**Re: Christina Lake Thermal Project Phase H and Eastern Expansion
Project Update and Supplemental Information Request 2 Responses
AER Application No. 1758947
EPEA Application No. 019-48522**

The purpose of this document is to provide responses to the Round 2 SIR package and provide updated information regarding the Project (Project Update). This document is organized into two parts as follows:

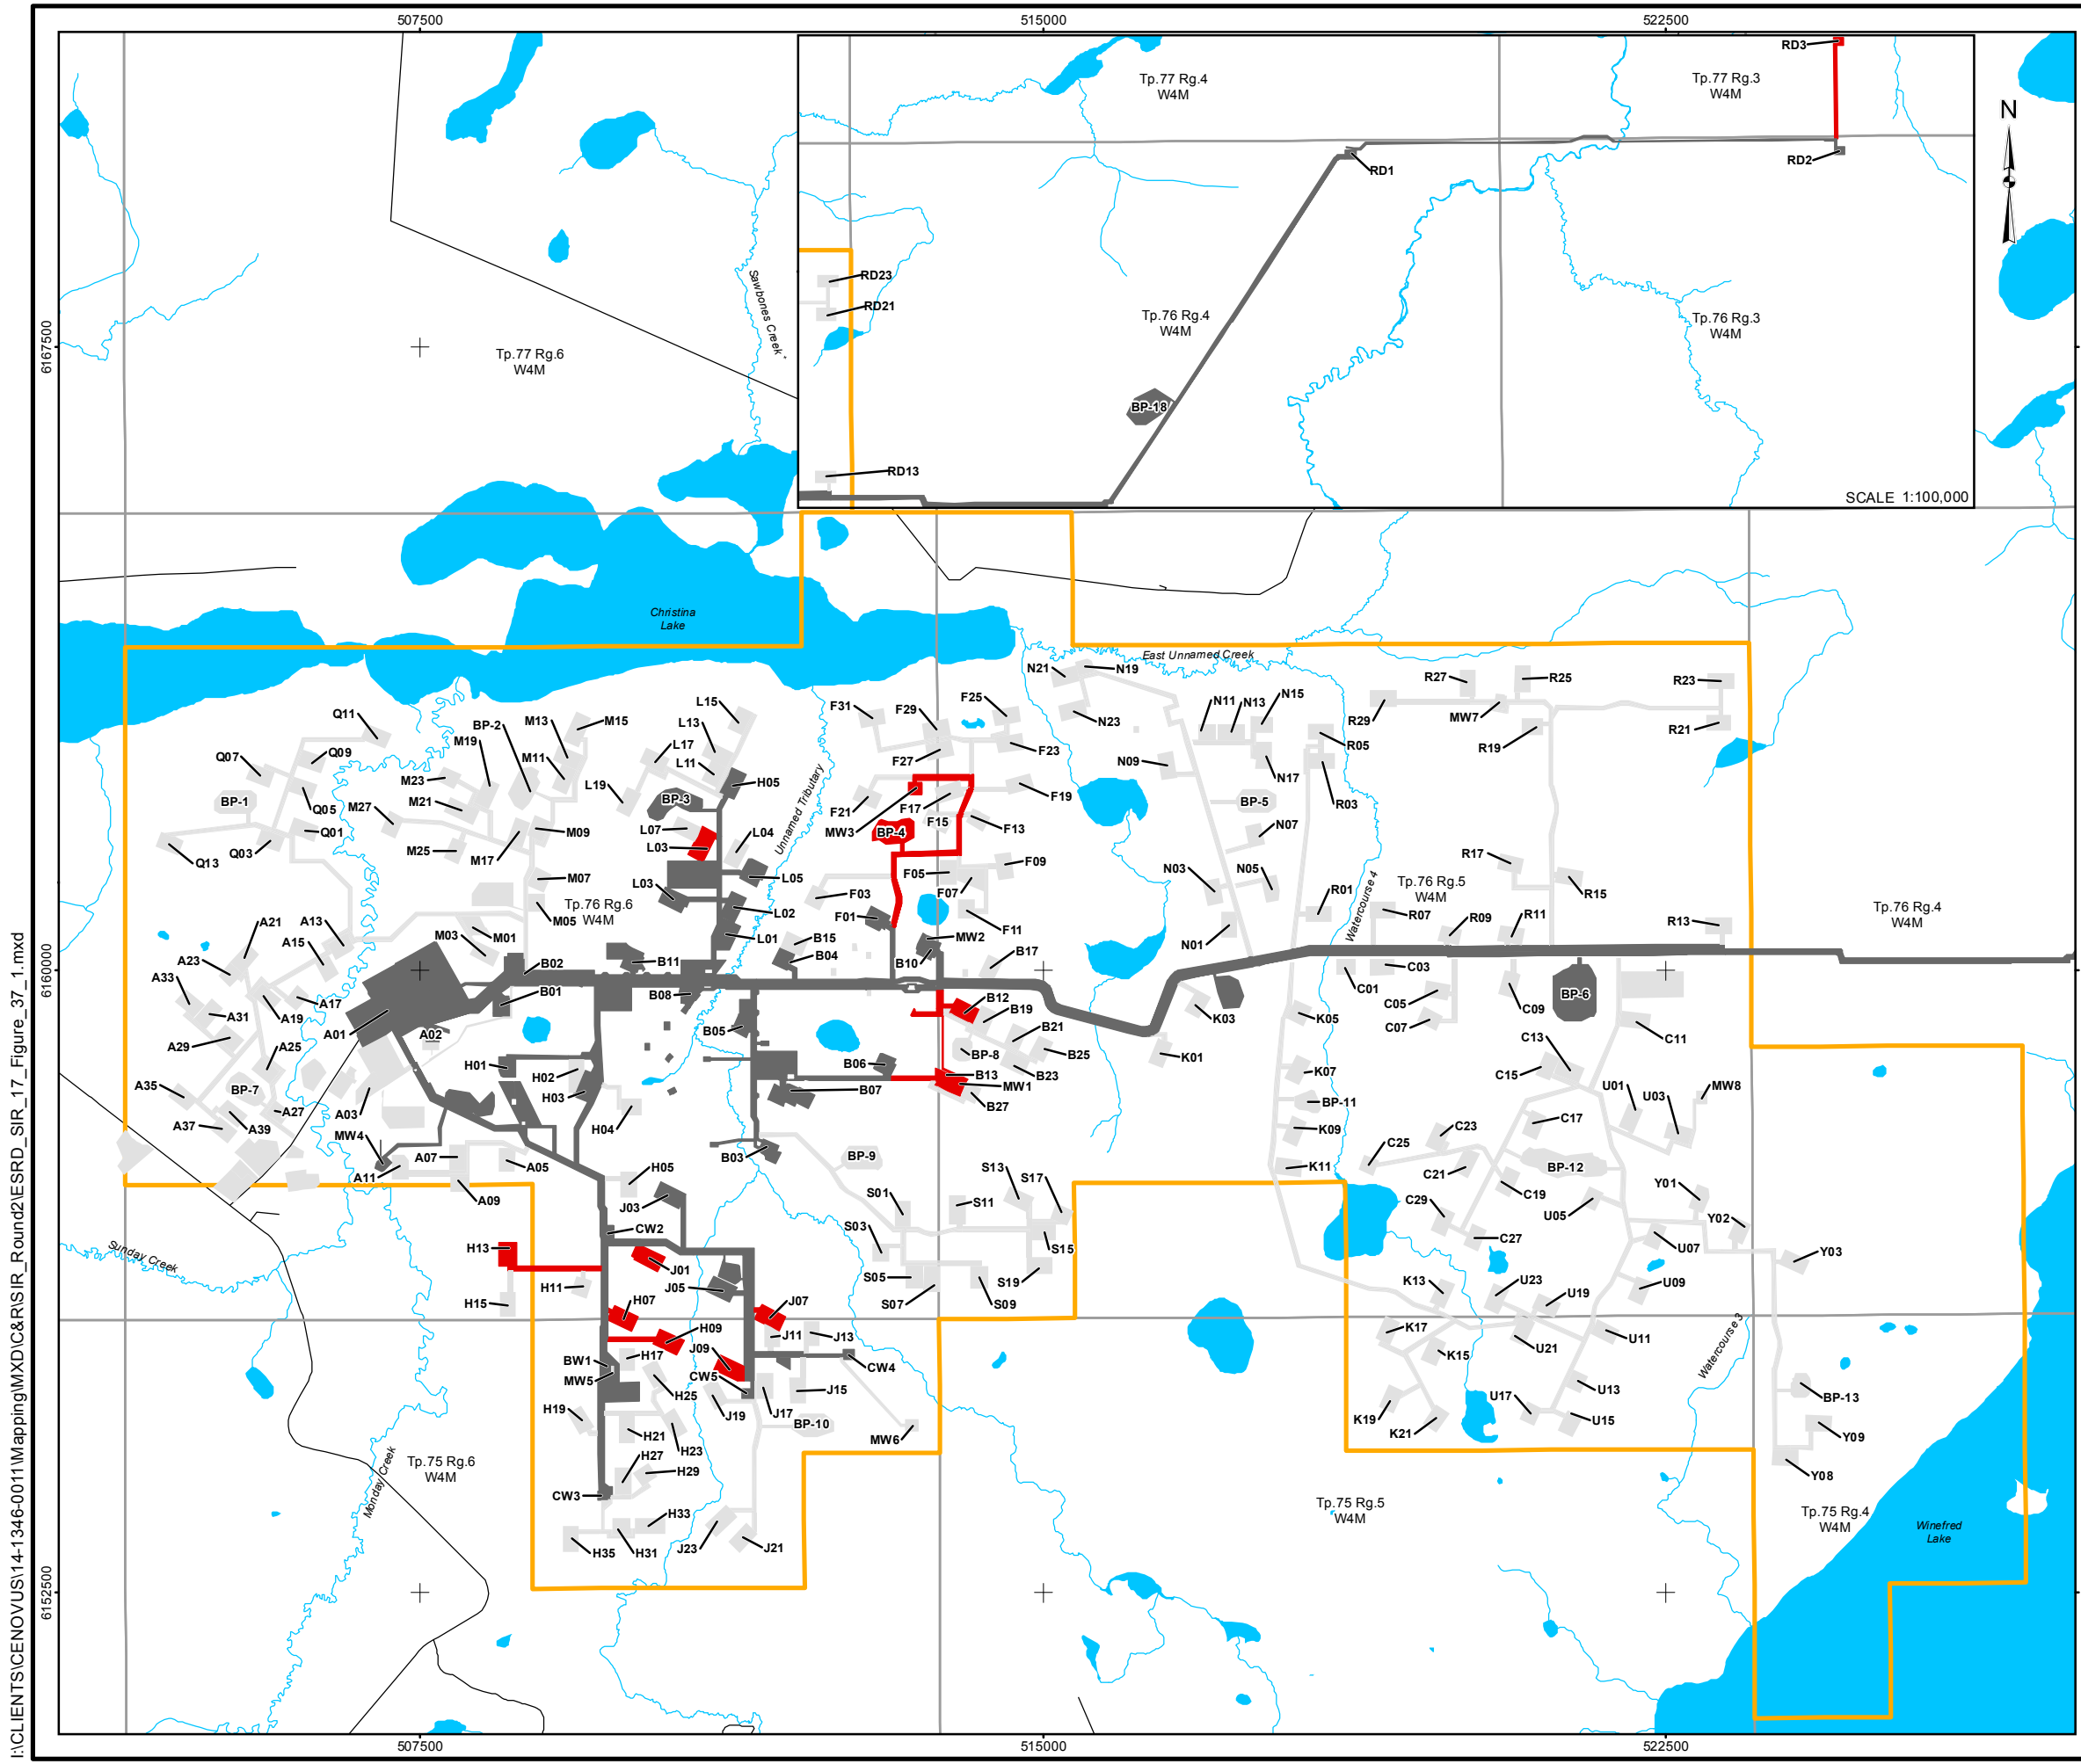
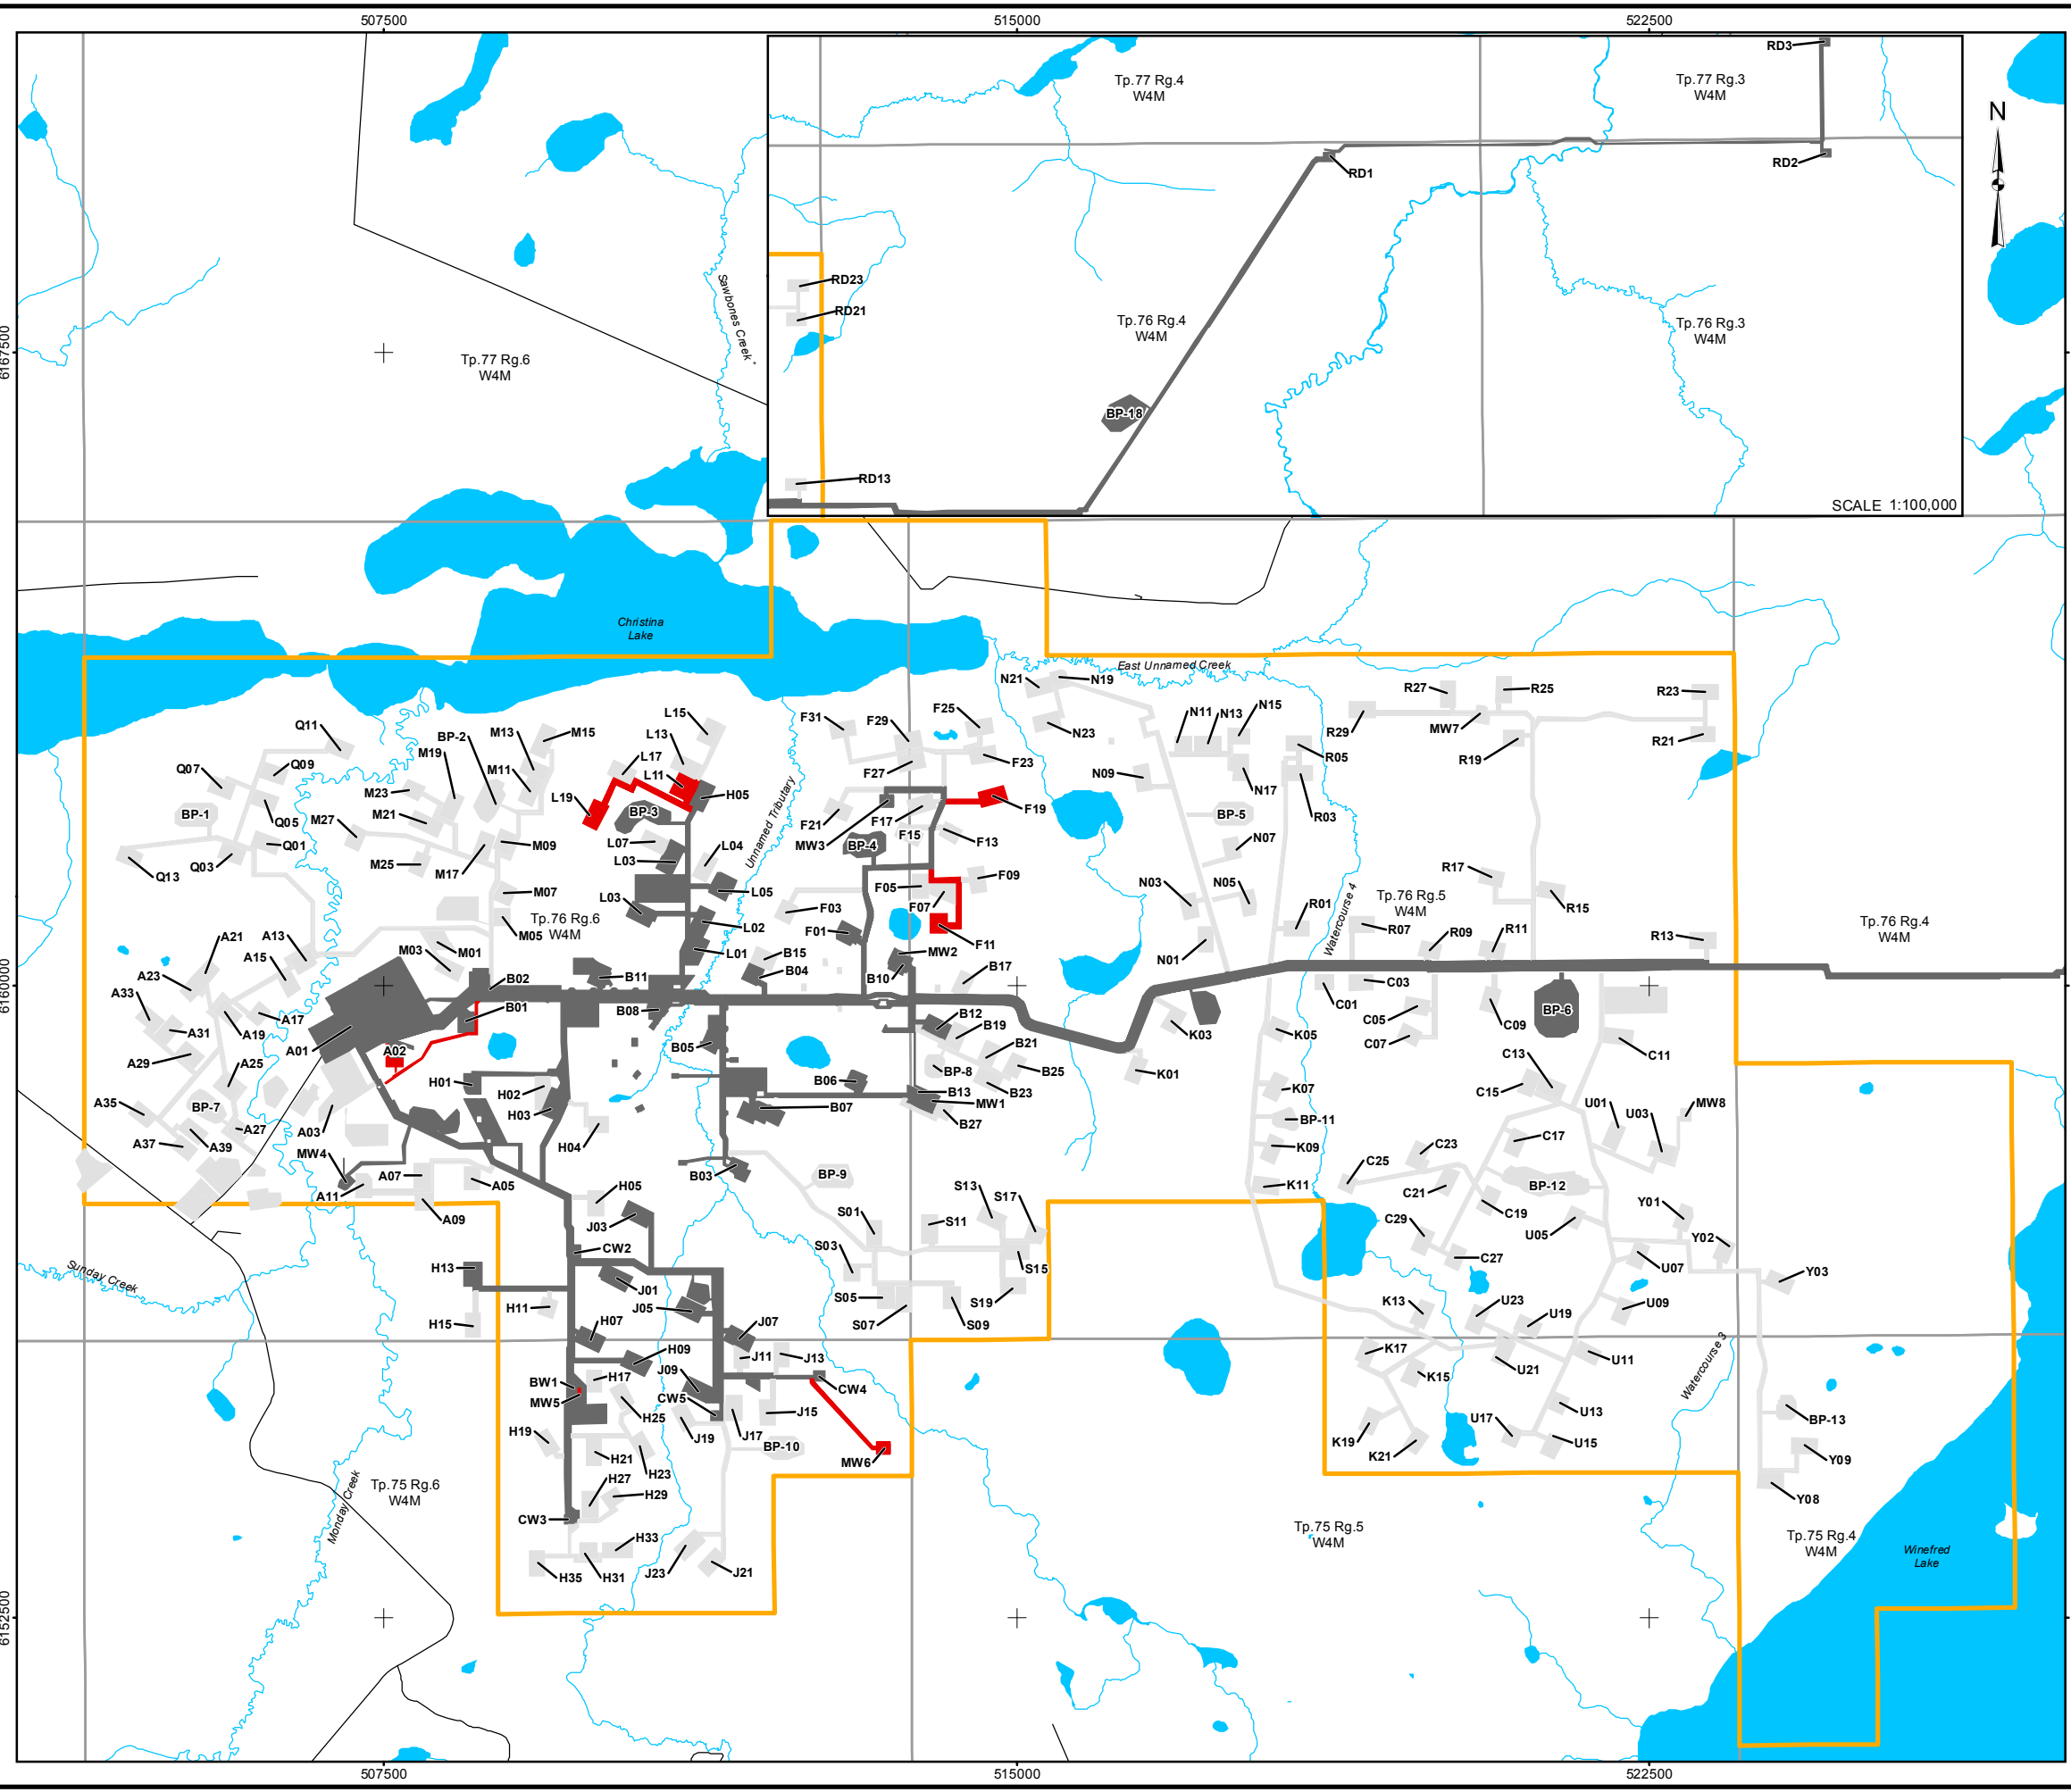
In Table 65-2, the column Unnamed (Monday) Creek appears to be mislabelled. All Figures in the SIR response 69 are mislabelled. In Figure 186-1, the sub-watershed is mislabelled.

Figures 69-1 to 69-13 from ESRD Round 1 SIR 69 have been revised and are presented as [Figures 37-1 to 37-13](#).
